# Design and access statement

**Erection of an attached two storey dwelling  
at  
Land Adjacent To 37 Latham Road, Twickenham**

### Pre-Planning Application

2 Proposed Rear Elevation  
1 : 100

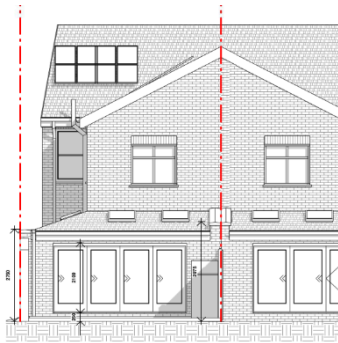
There is concern, however, with the additional accommodation within the roof, which is not entirely suitable to the existing context, and is also not considered to follow best practice guidance within the Design Quality SPD (2006) (particularly 'character'). ....

The insertion of a balcony disrupts the regular rhythm of outriggers and thus is uncharacteristic in the design intention of the house.

Reply: Additional accommodation within the roof has been removed in this submitted planning application proposal . Also the balcony has been removed, in this submitted planning application proposal.

Bird brick:

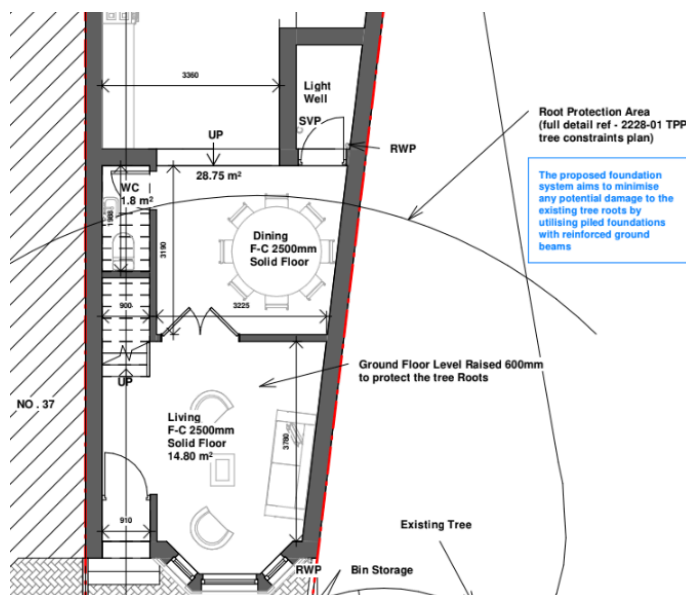
It is also thought that bat and bird bricks should be incorporated into the design of the new building. The bird bricks should be designed for swifts or house sparrows.

Reply: Bat brick is added in side elevation .

Reply: Bat brick is added inside elevation .

Tree Protection Plan:

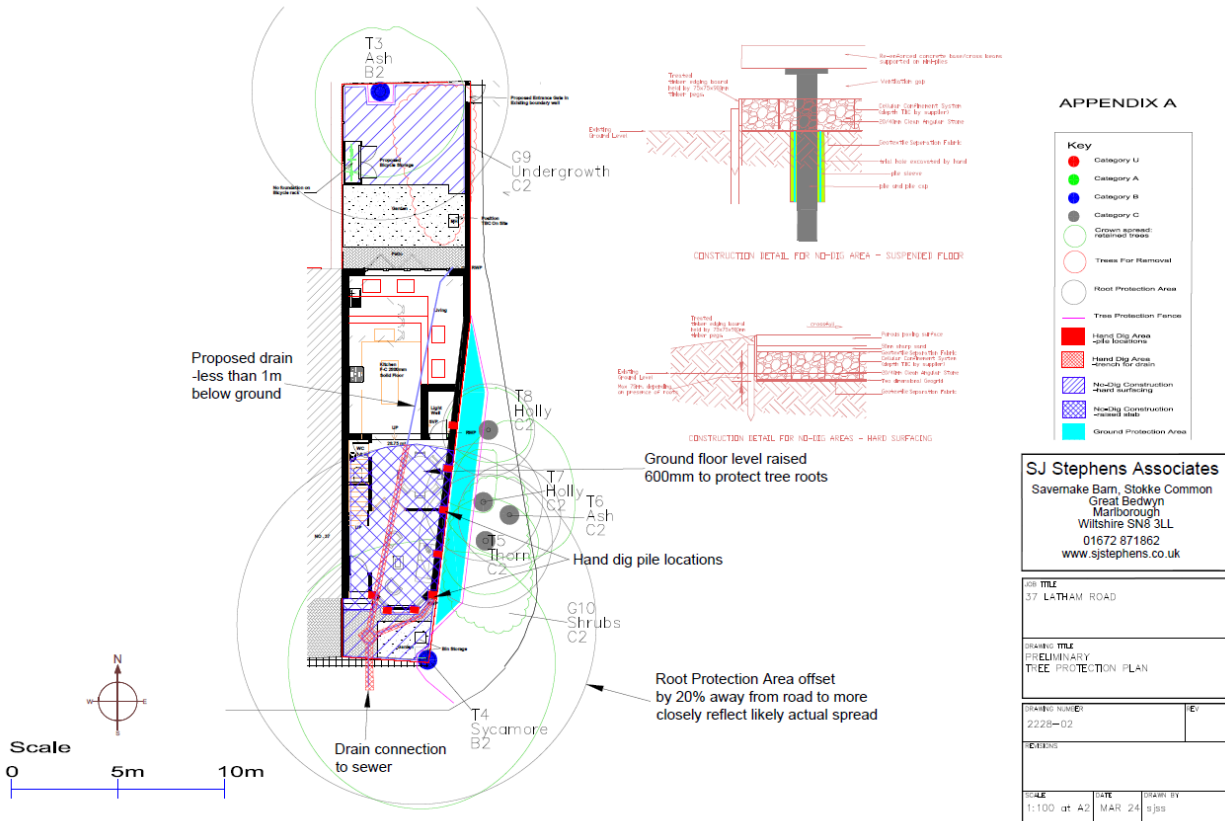
The proposed design creates conflicts with the Sycamore above and below ground. Pruning works would be required to facilitate the design and an assessment of these would be expected in any submission.

The authority has permitted removal of its trees where sufficient public benefit was demonstrated that this was justified. If this was such a case, we would expect a payment of the CAVAT value of the tree, the costs of removal, and of administration, to be made as a S106 agreement to the trees team to fund replacement planting. I see no evidence that this case would meet these criteria, making the removal unacceptable.

Reply: Please see the detailed Arboricultural Impact Assessment and Tree Protection Plan. We have designed the proposed foundation system aims to minimise any potential damage to the existing tree roots by utilising piled foundations with reinforced ground beams

Ground floor would be of suspended slab construction with a gap between soil and slab. Any below ground drainage and piles will be using hand dig method within TPA
